Zilker Neighborhood Association

November 4, 2021

Re: Agenda item 56, Rezoning of 2700 South Lamar, Case C14-2020-0144

Figure 7
Topography

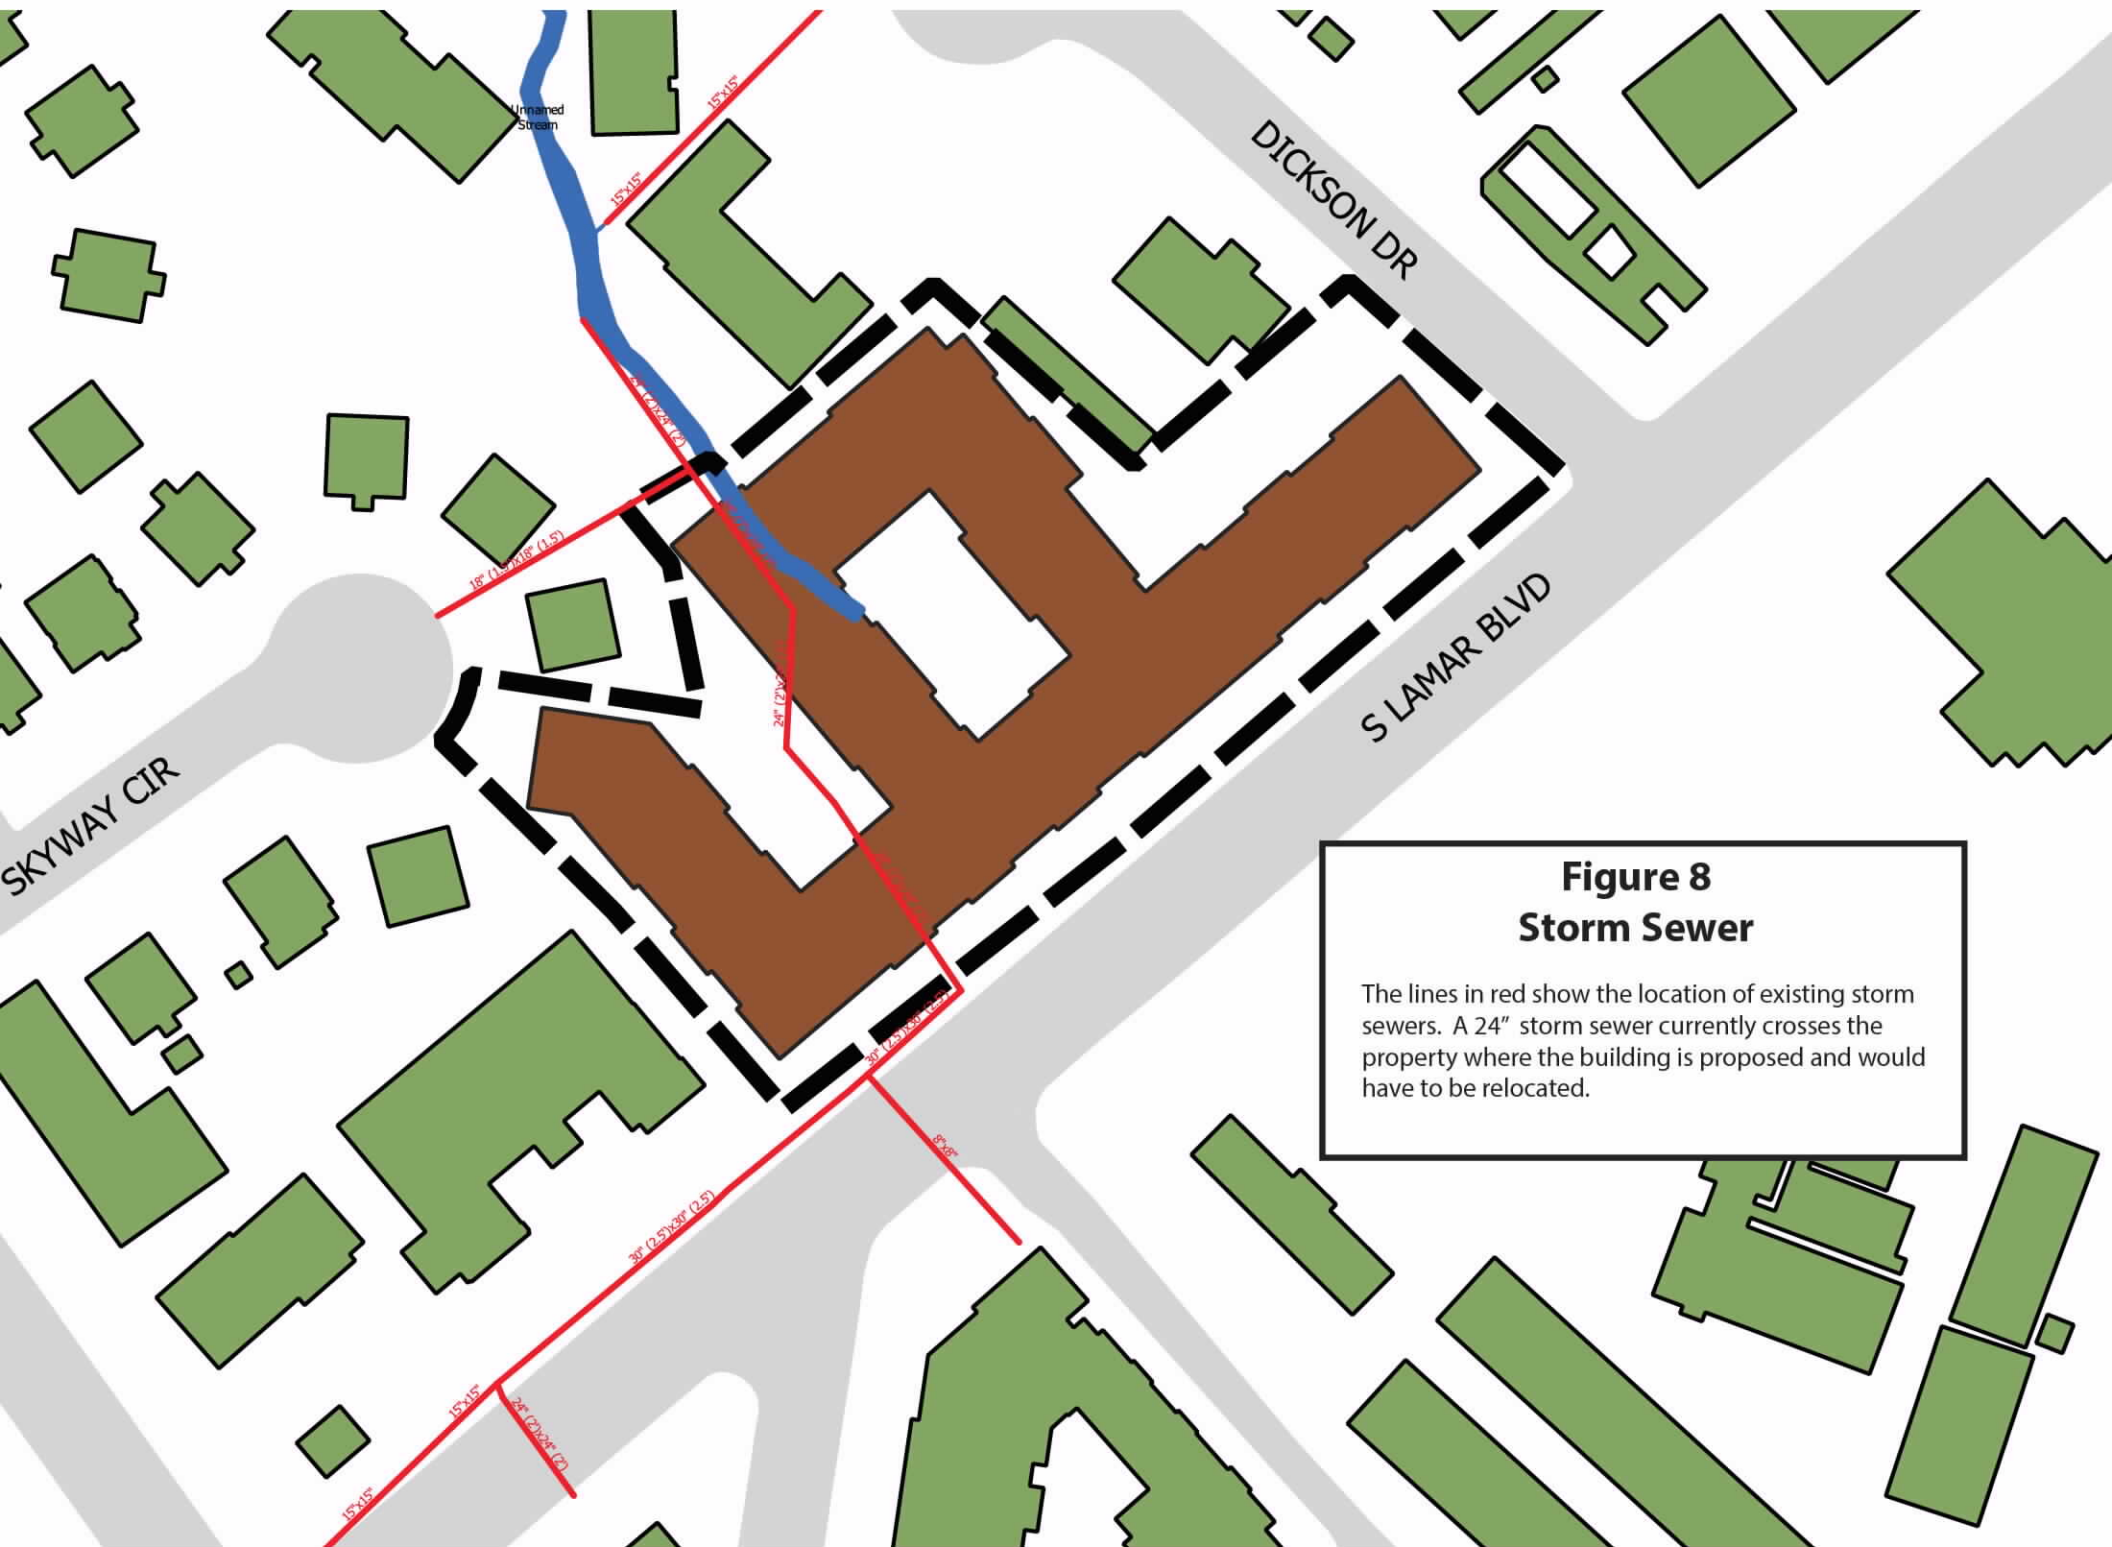
The site has some topography with significant relief as a result of an intermittent creek which runs through it (see Figure 7). It is very likely that this creek, a creek that may contribute recharge to the Edwards Aquifer and Barton Springs, will be filled in as a result of the construction. Protections should be added to preserve the creek, trees, and other environmental features and to prevent flooding of the multifamily community downstream from the project. These would be in addition to the SOS water quality requirements.

The site has an intermittent creek running partially through it with an elevation difference of 14 feet. The slope ranges from 13% (A) to 21% (B). Construction of the building will likely result in the stream being filled in.
